Addendum No. 01

Subject: Andrew J. Morrison Elementary School – Fire Alarm System Replacement
SDP Contract No. B-009 (C) of 2017/18

This Addendum 01, dated January 30, 2018 shall modify and become part of the Contract Documents for the work of this project. Any items not mentioned herein, or affected by, shall be performed strictly in accordance with the original documents.

DRAWING NO.
ED100A

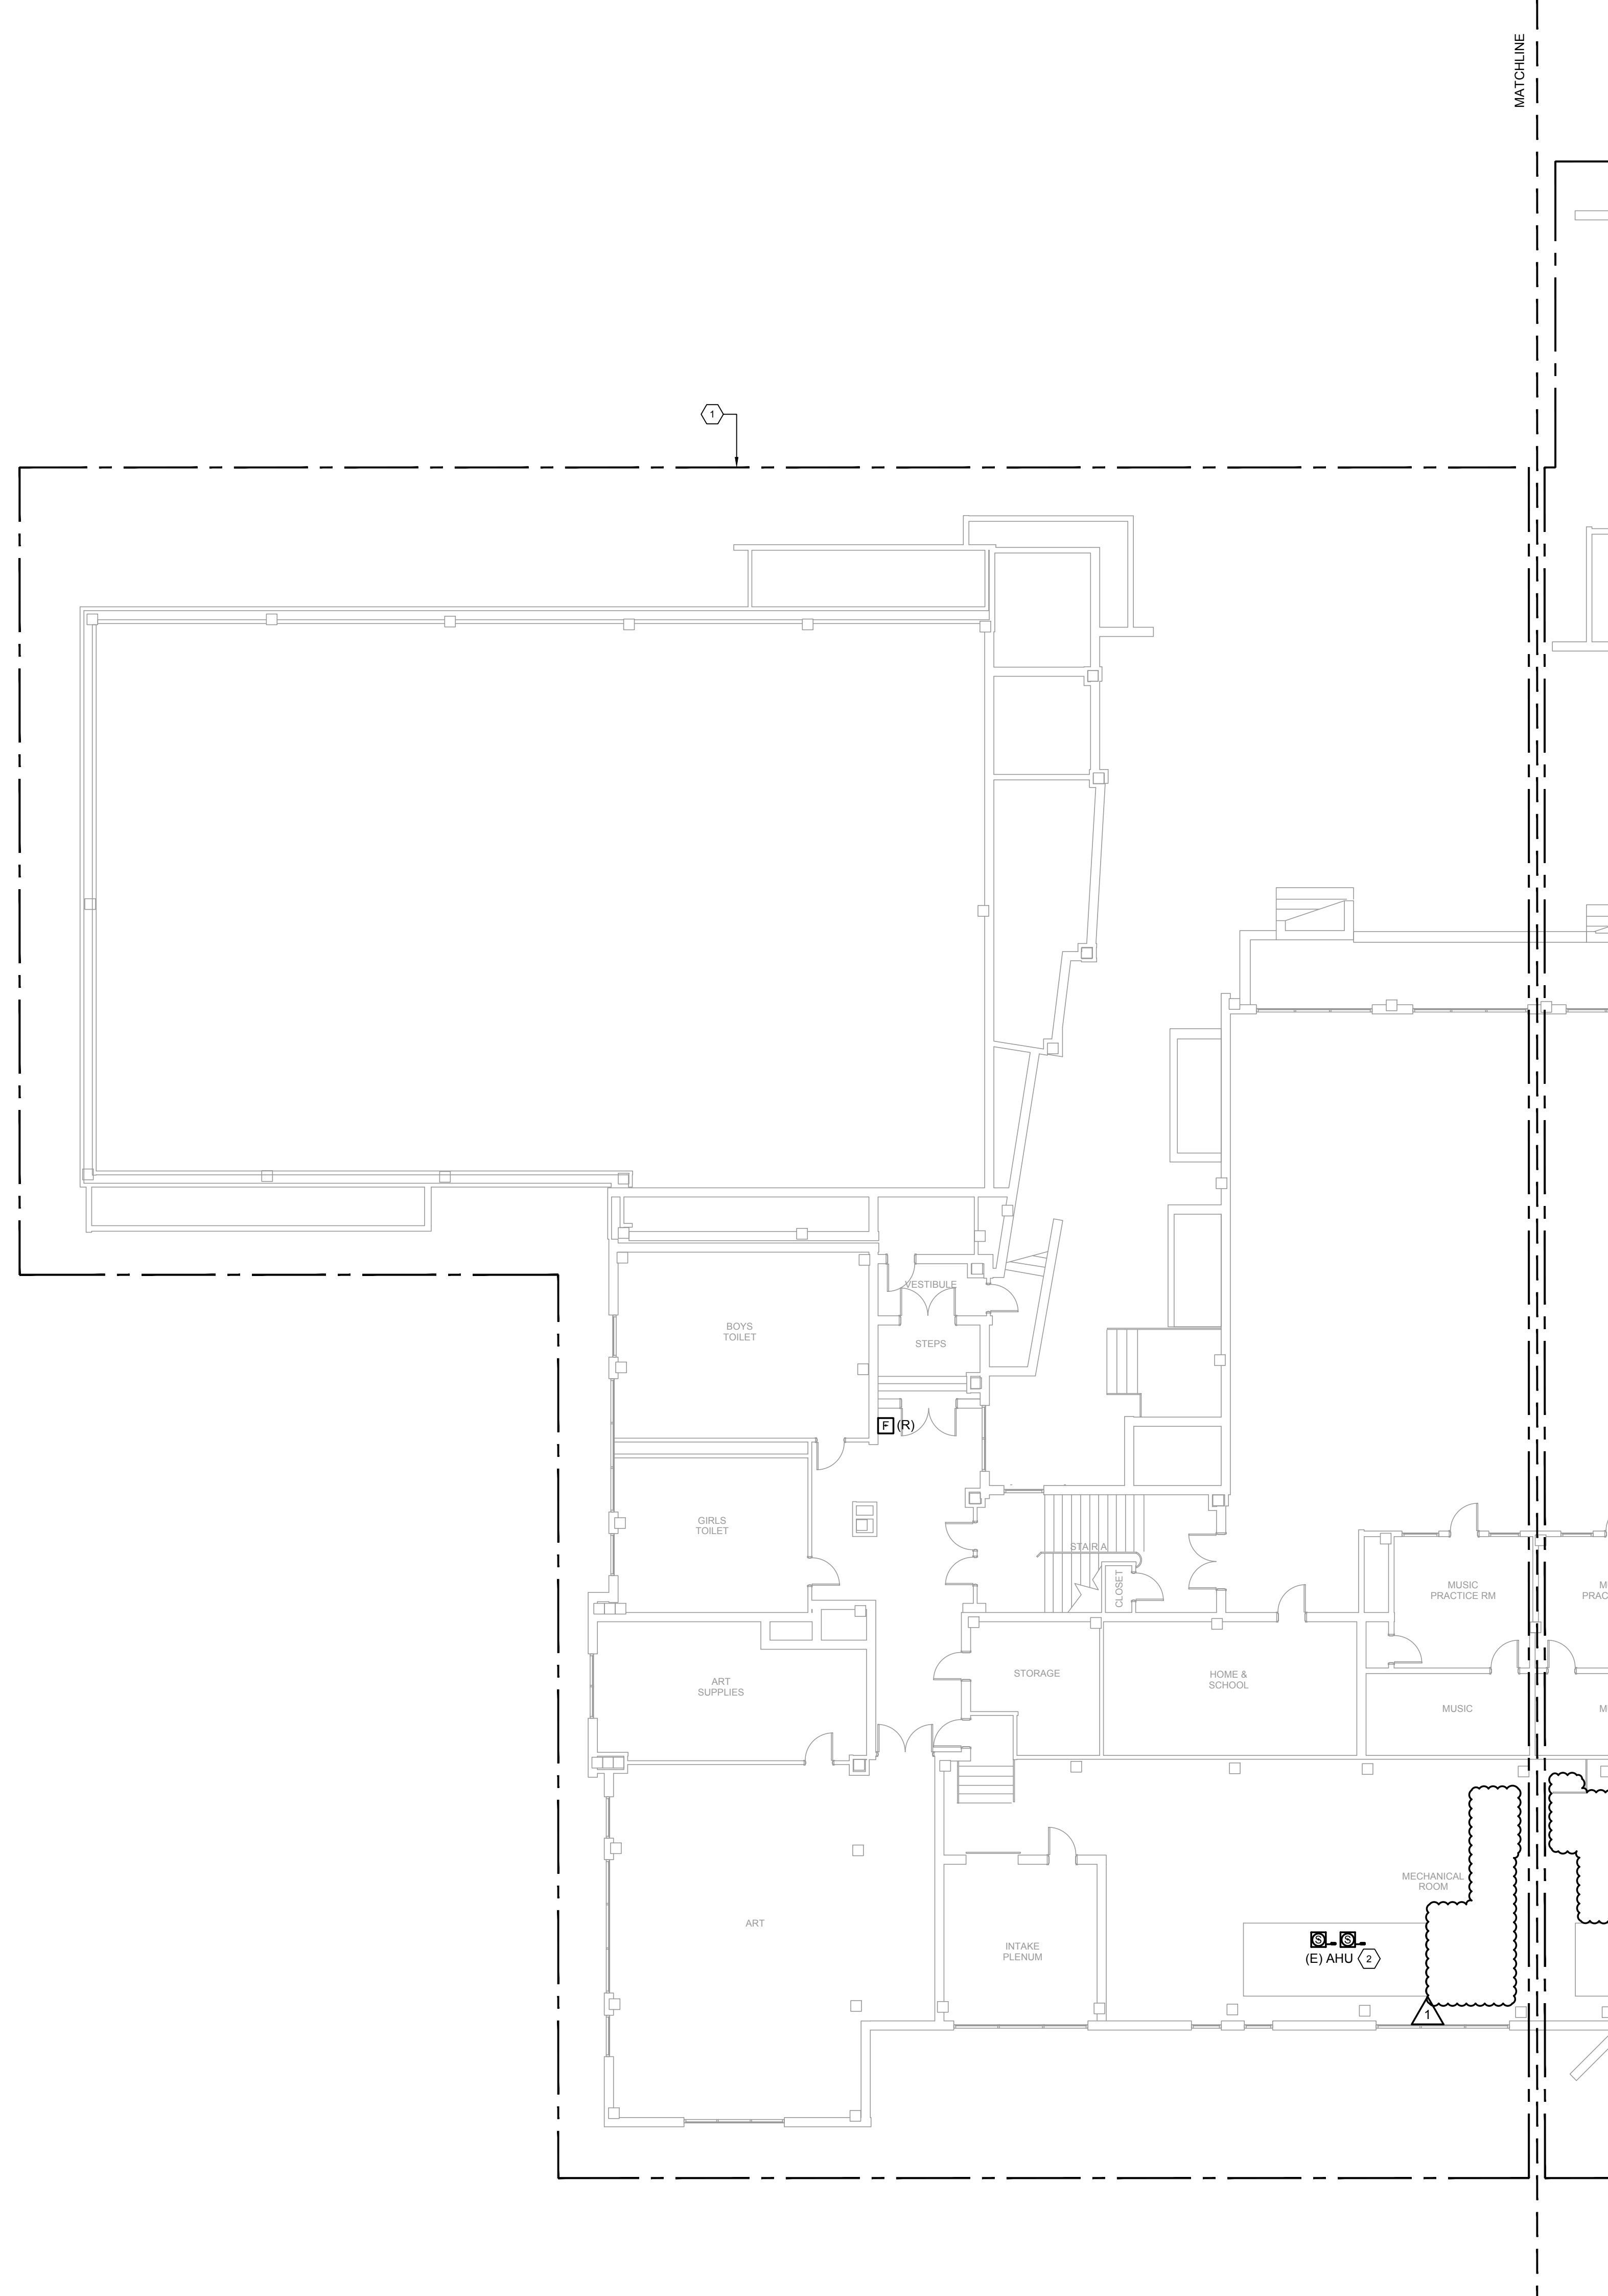
Drawing ED100A – Removed Keynote #6. Removed scope of work for AHU motor replacement.

DRAWING NO.
ED100B

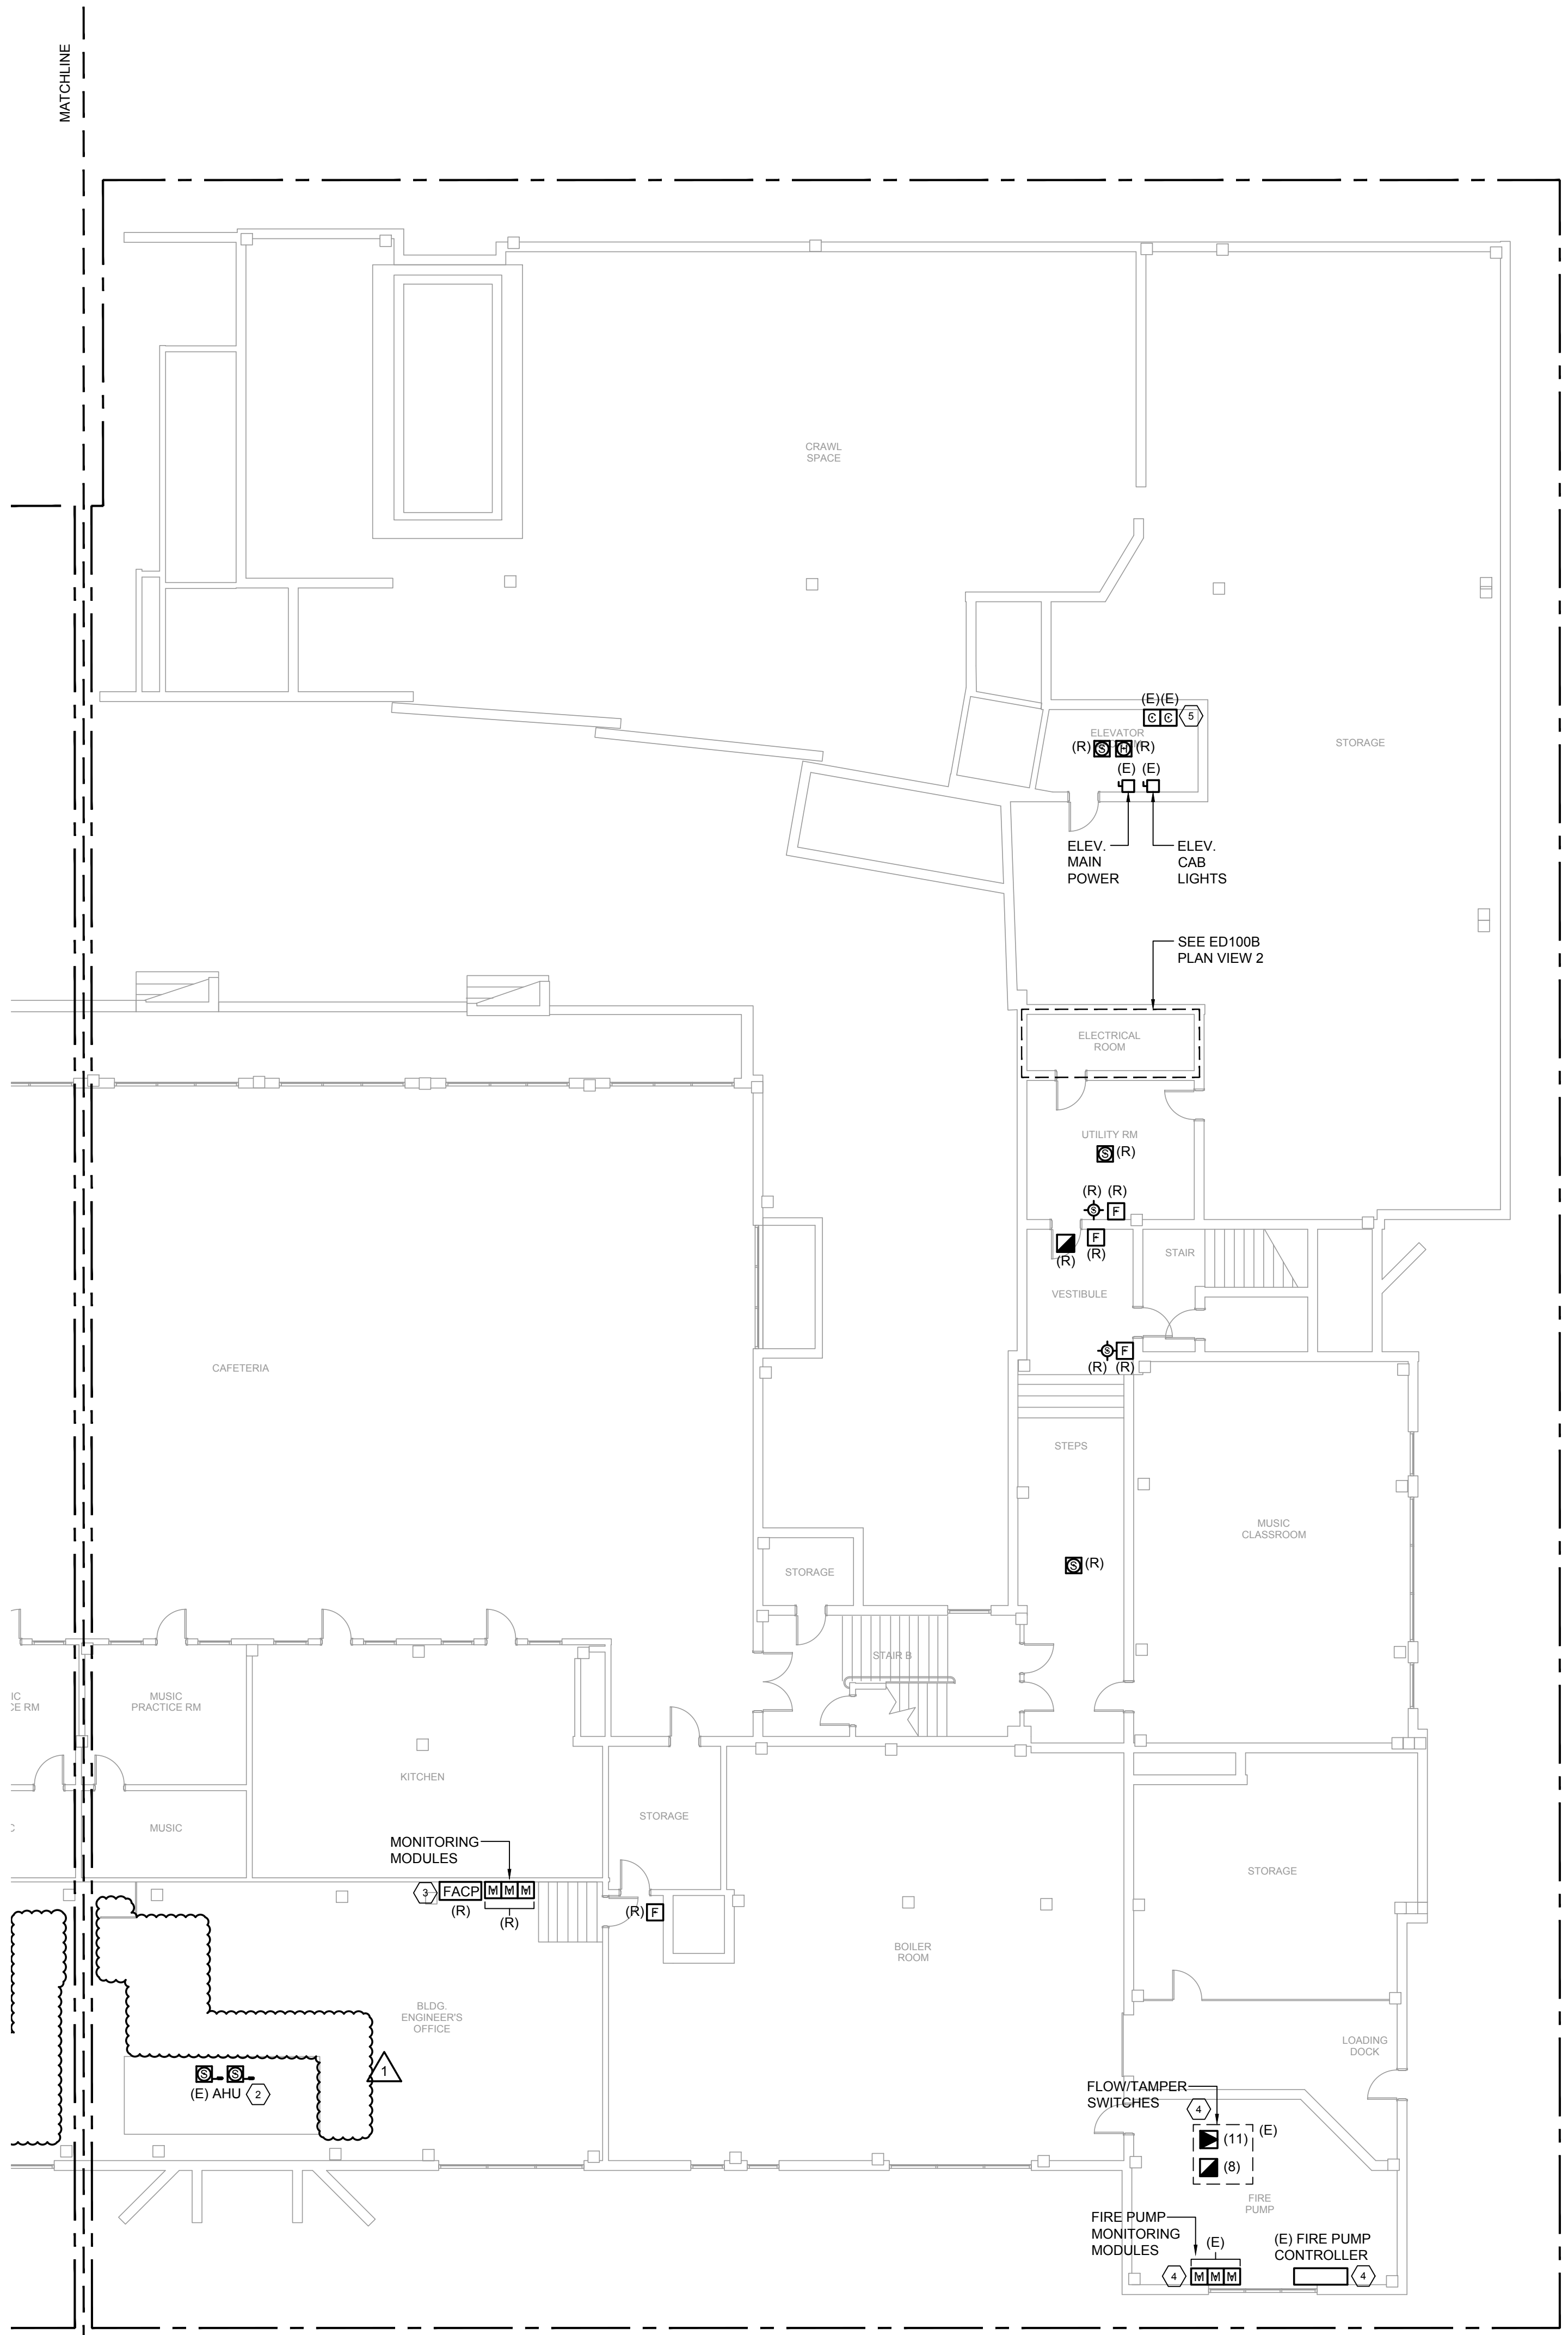
Drawing ED100B – Removed Keynote #6. Removed scope of work for AHU motor replacement.

DRAWING NO.
E100A

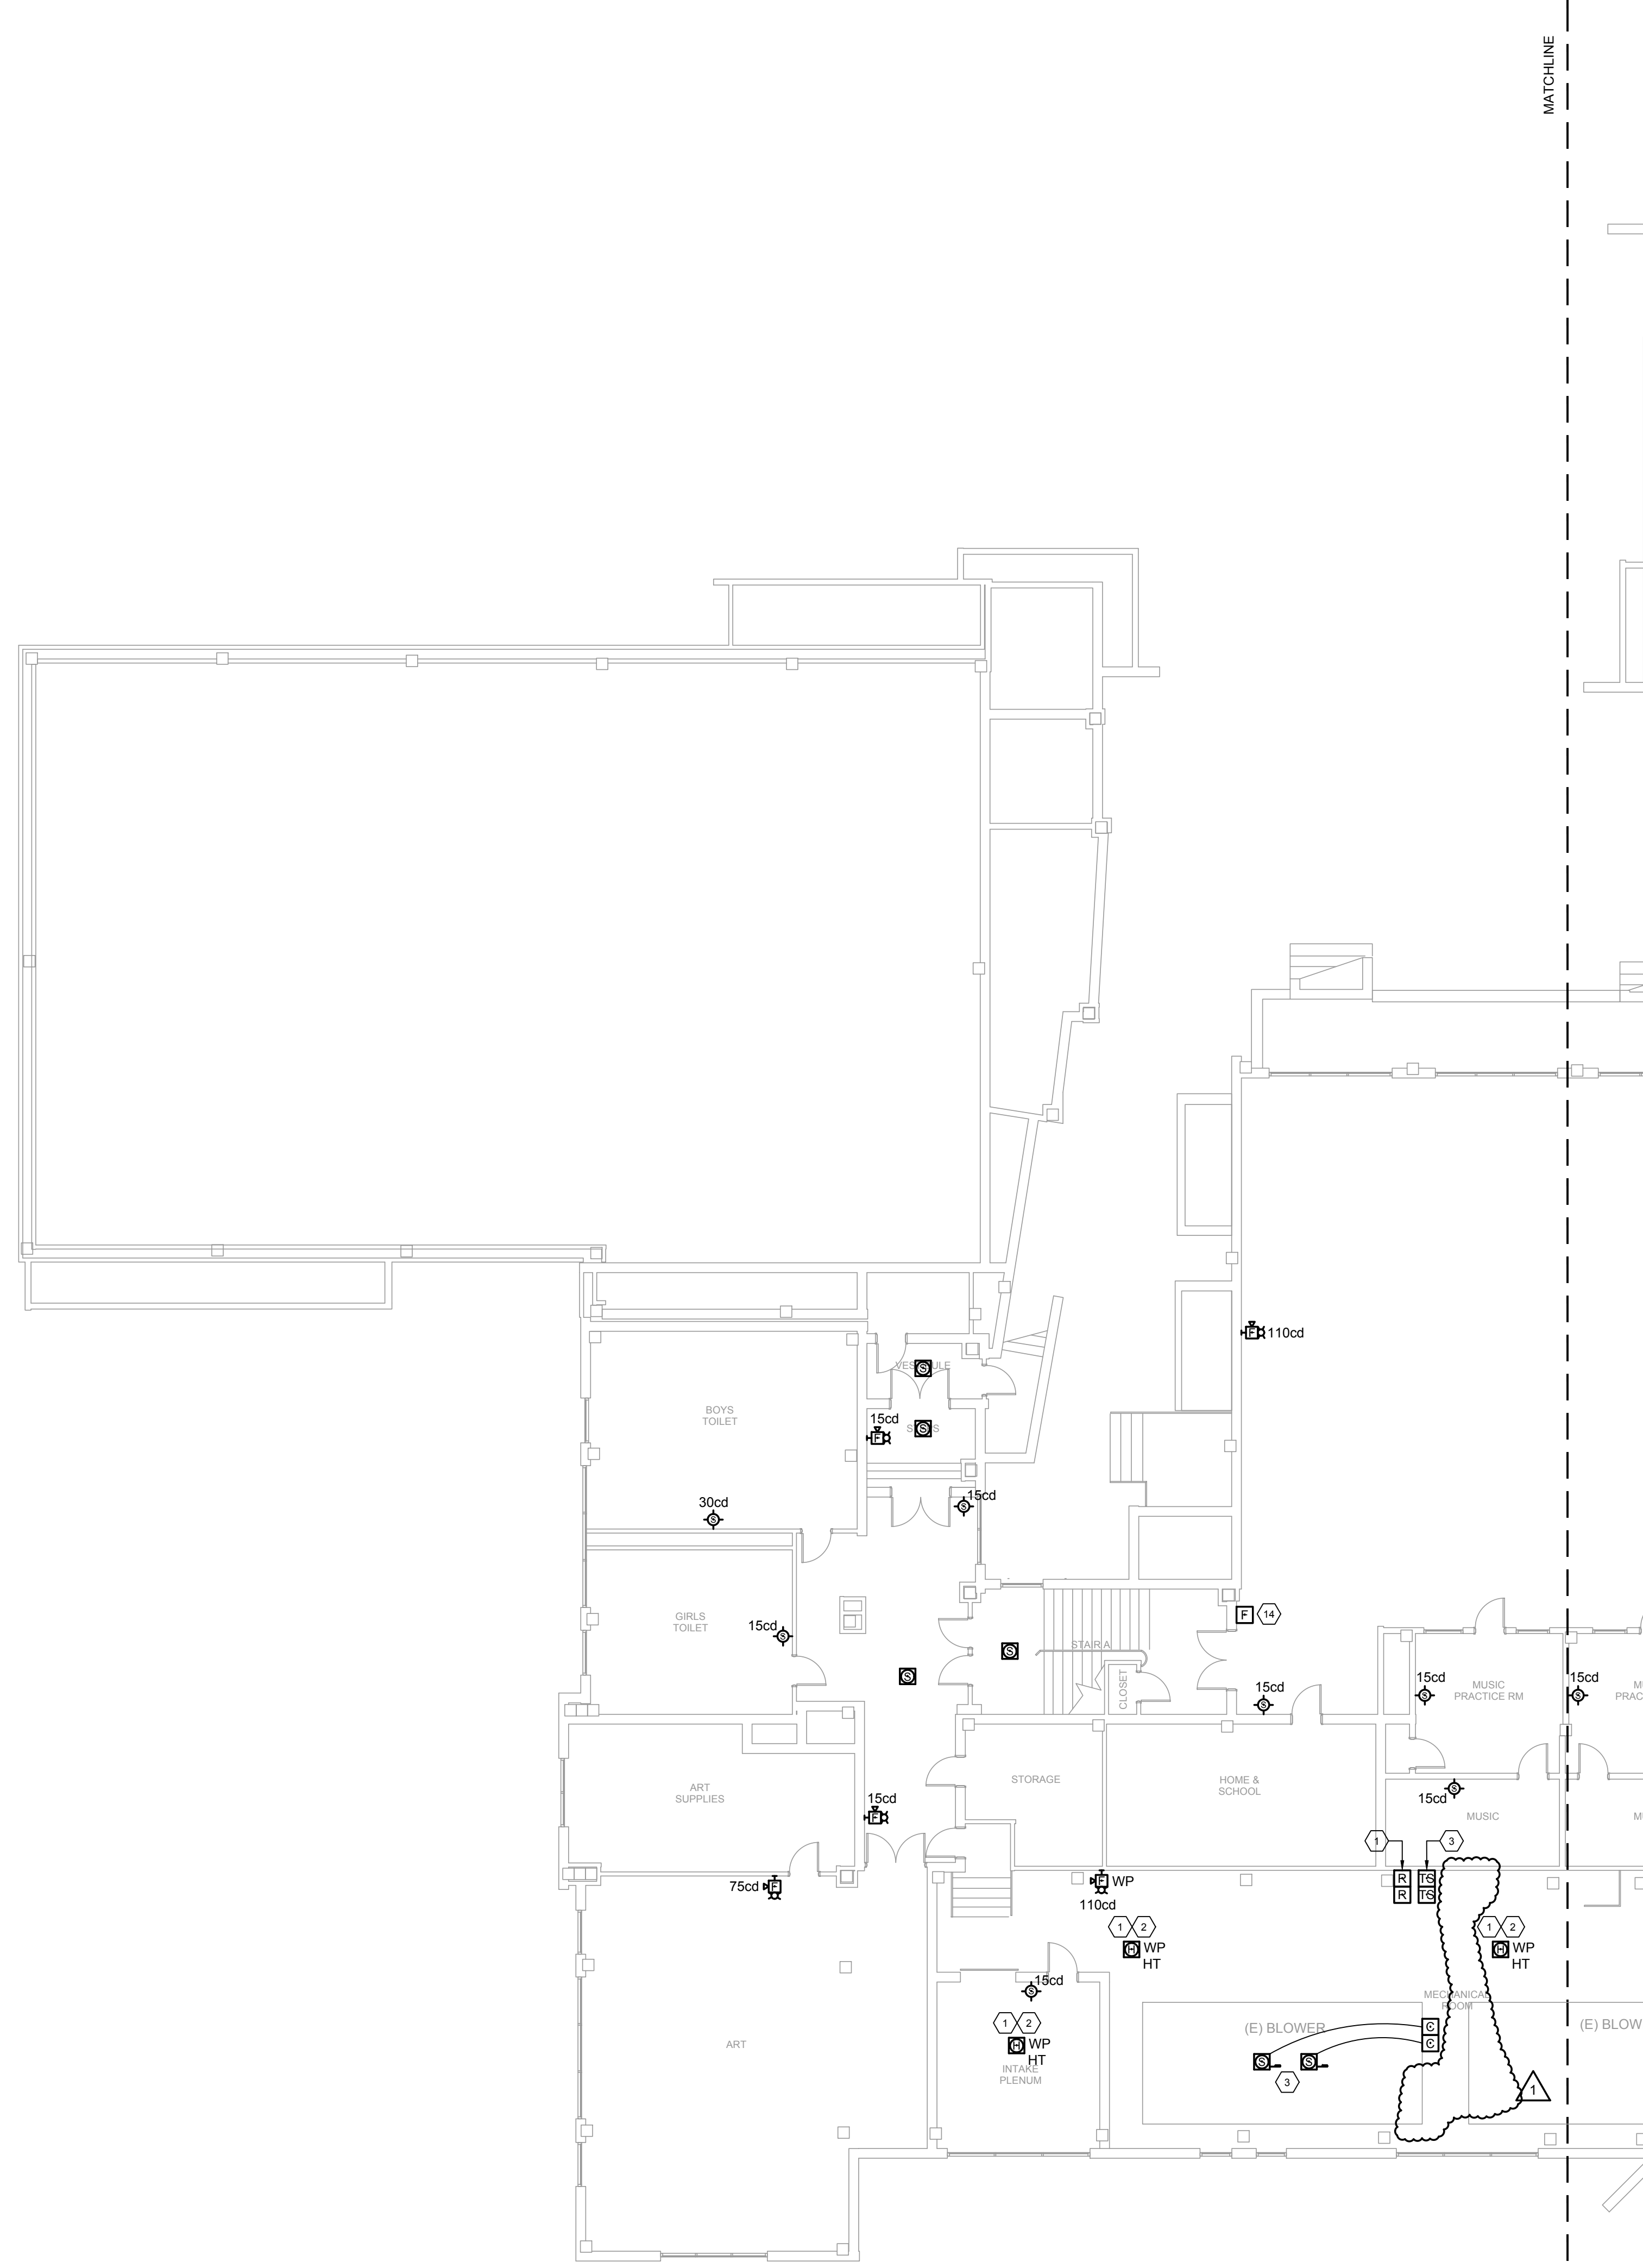
Drawing E100A – Revised Keynote #8, removed requirement for (2) copper telephone lines to FACP.

Removed Keynote #5 and #12. Removed scope of work for AHU motor replacement.
